ADDENDUM #1

Reference: **Security and Flooring Improvements
Brigham City First District Courts – Brigham City, Utah**

DFCM Project No. 07135150

**BRIGHAM CITY COURT
TERRAZZO FLOOR /
SECURITY ENTRANCE REMODEL**
DFCM Project No. 07135150

ASD-01

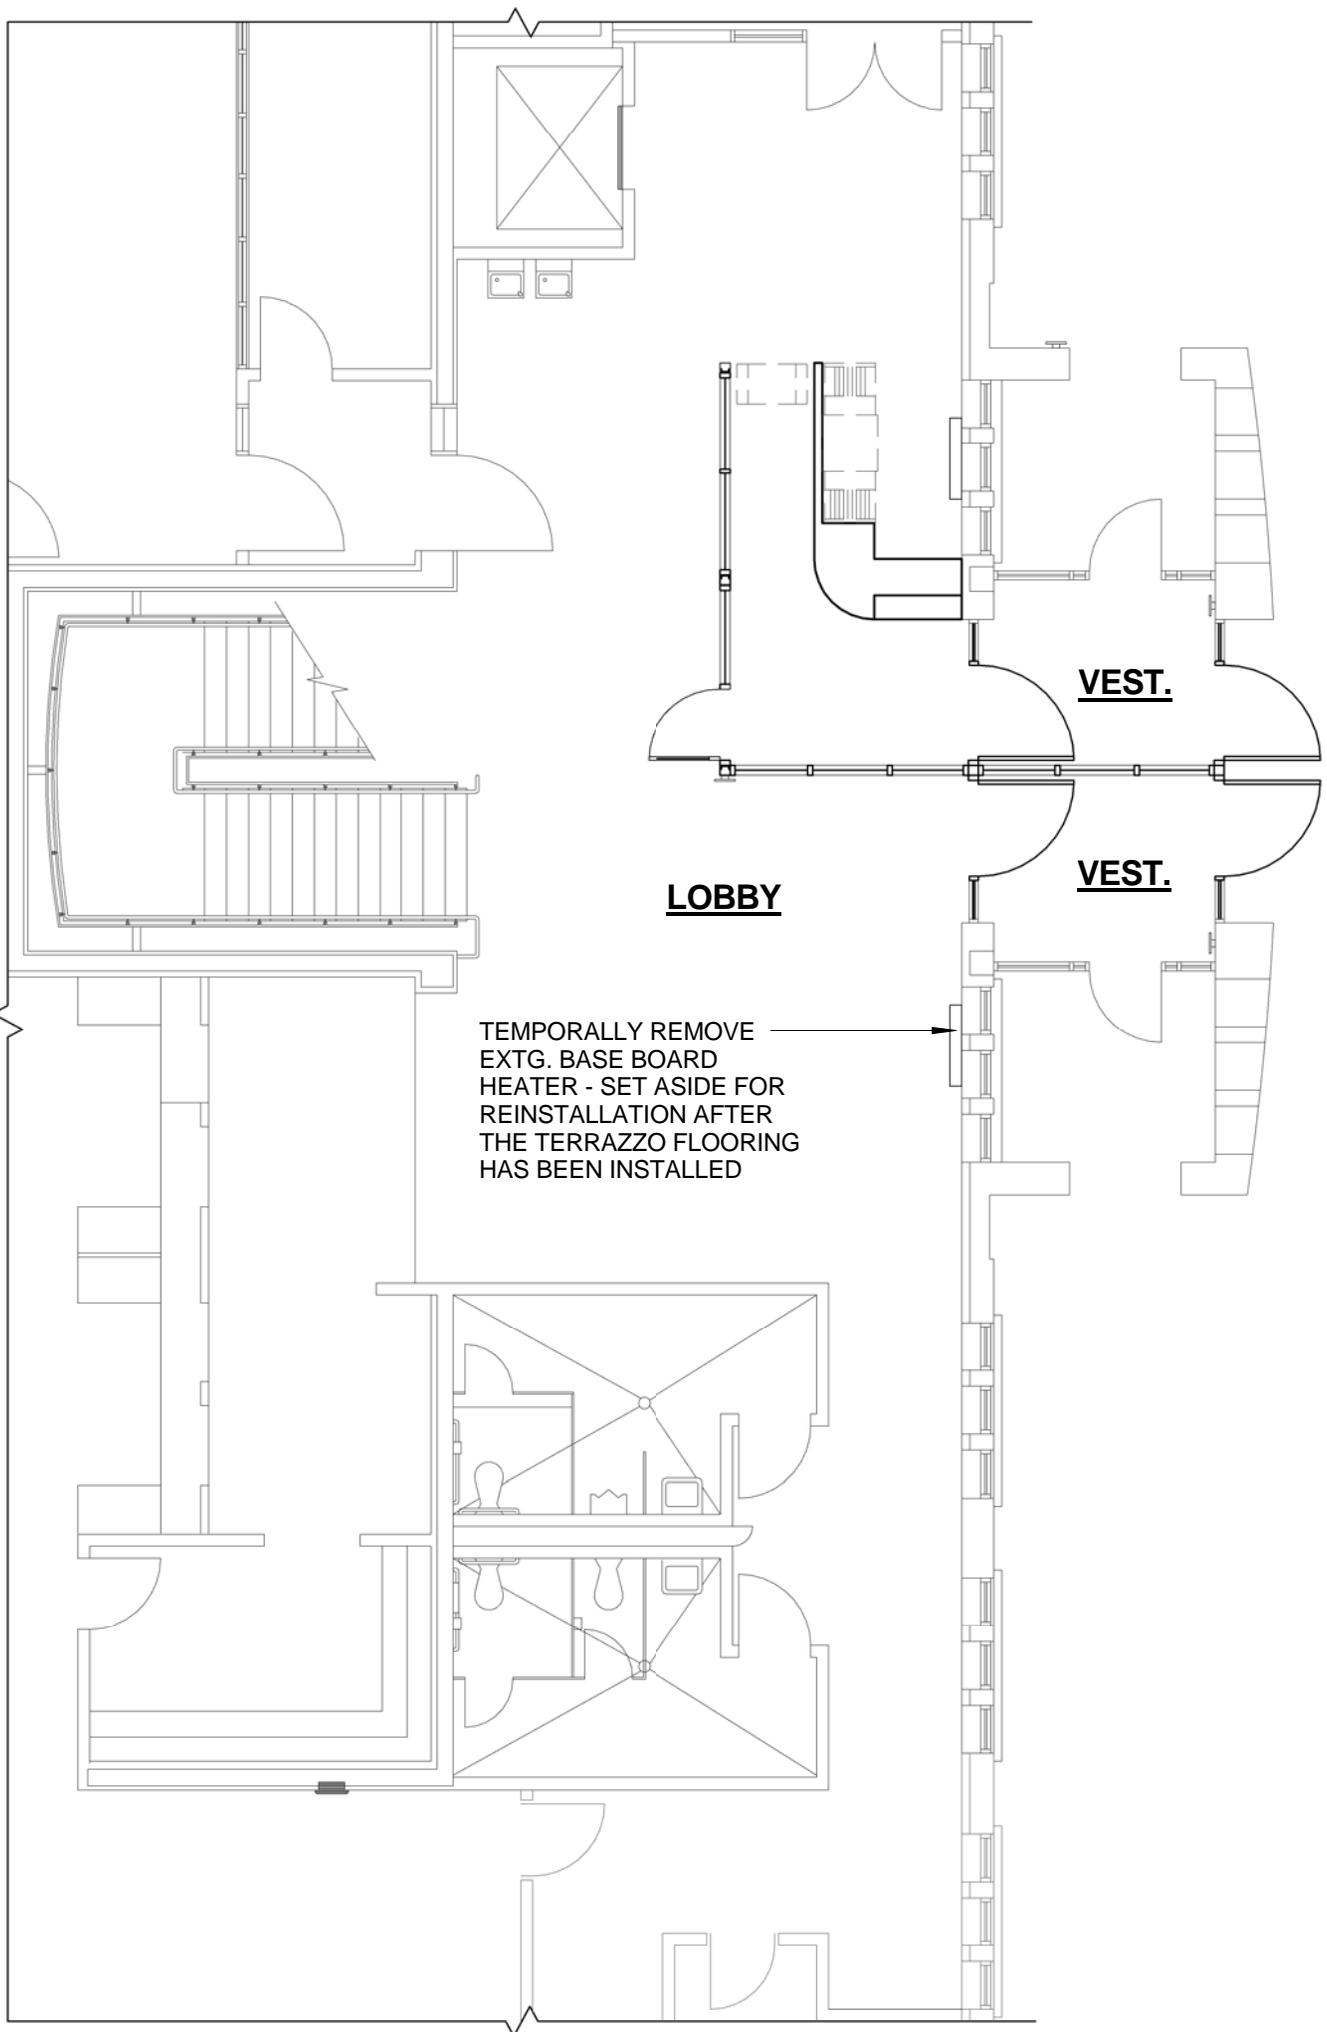
Temporally remove existing base board heater – set aside for reinstallation after terrazzo flooring has been installed. Refer to ASD-01 for location.

ASD-02

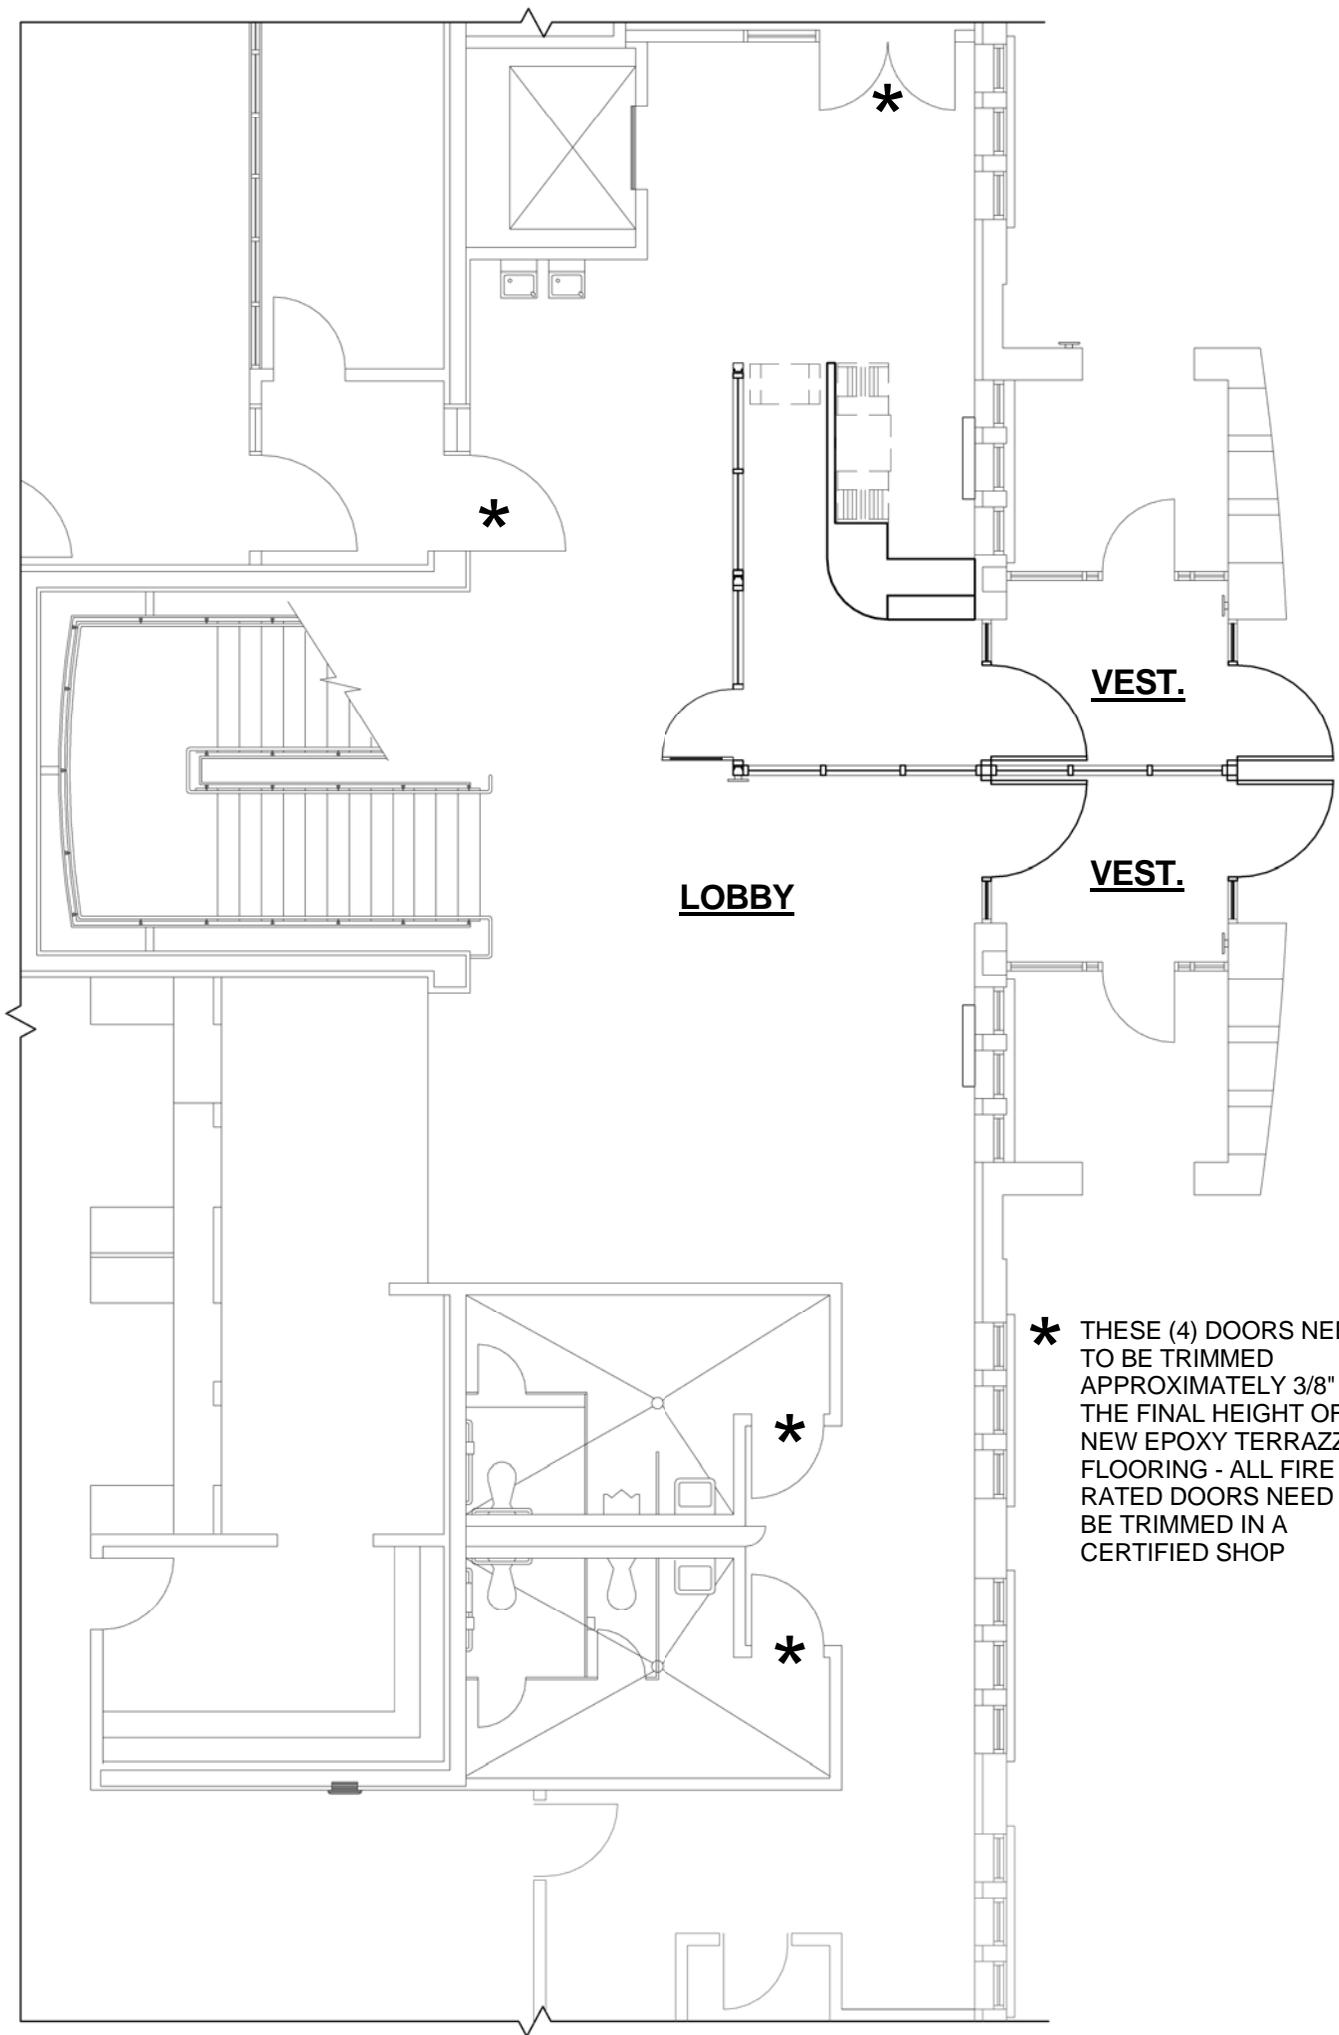
There are (4) doors that need to be trimmed approximately 3/8” or the final height of the new epoxy terrazzo flooring. All fire rated doors need to be trimmed in a certified shop. See attached ASD-02 for location of doors.

* THESE (4) DOORS NEED TO BE TRIMMED APPROXIMATELY 3/8" OR THE FINAL HEIGHT OF THE NEW EPOXY TERRAZZO FLOORING - ALL FIRE RATED DOORS NEED TO BE TRIMMED IN A CERTIFIED SHOP

ASD-03 BASE DETAIL

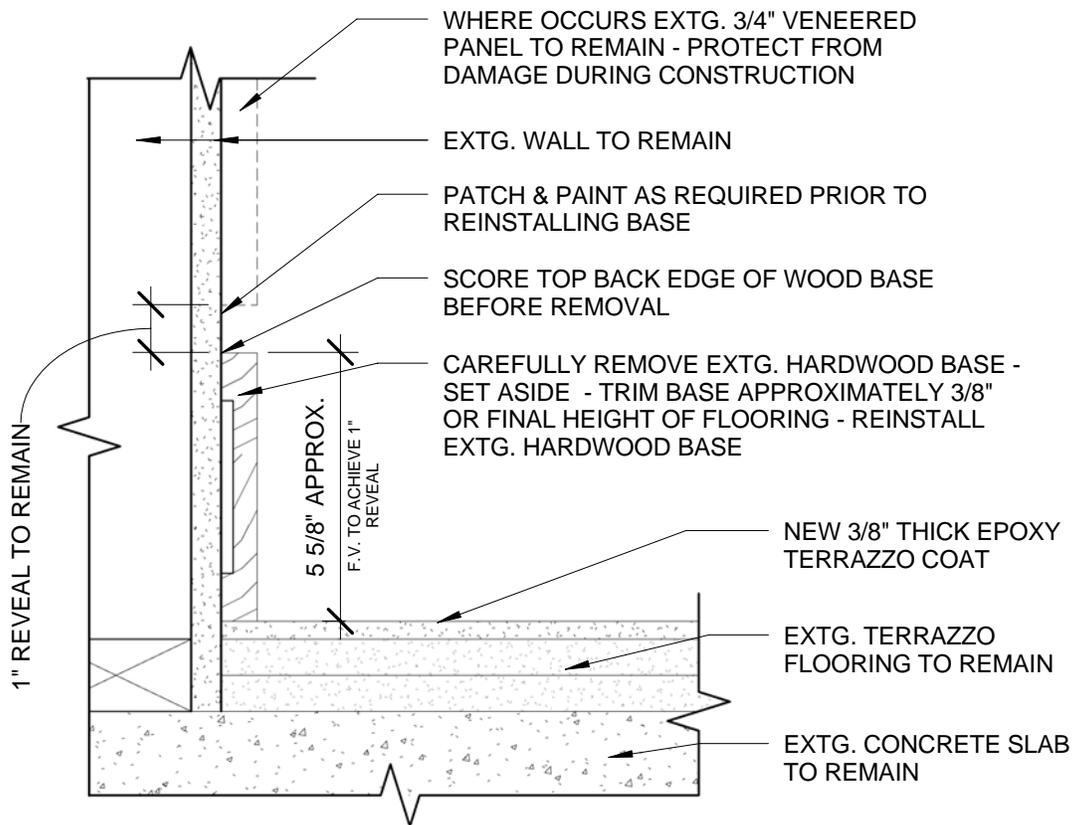
Replace drawing C3/AE-501 with the attached drawing ASD-03.
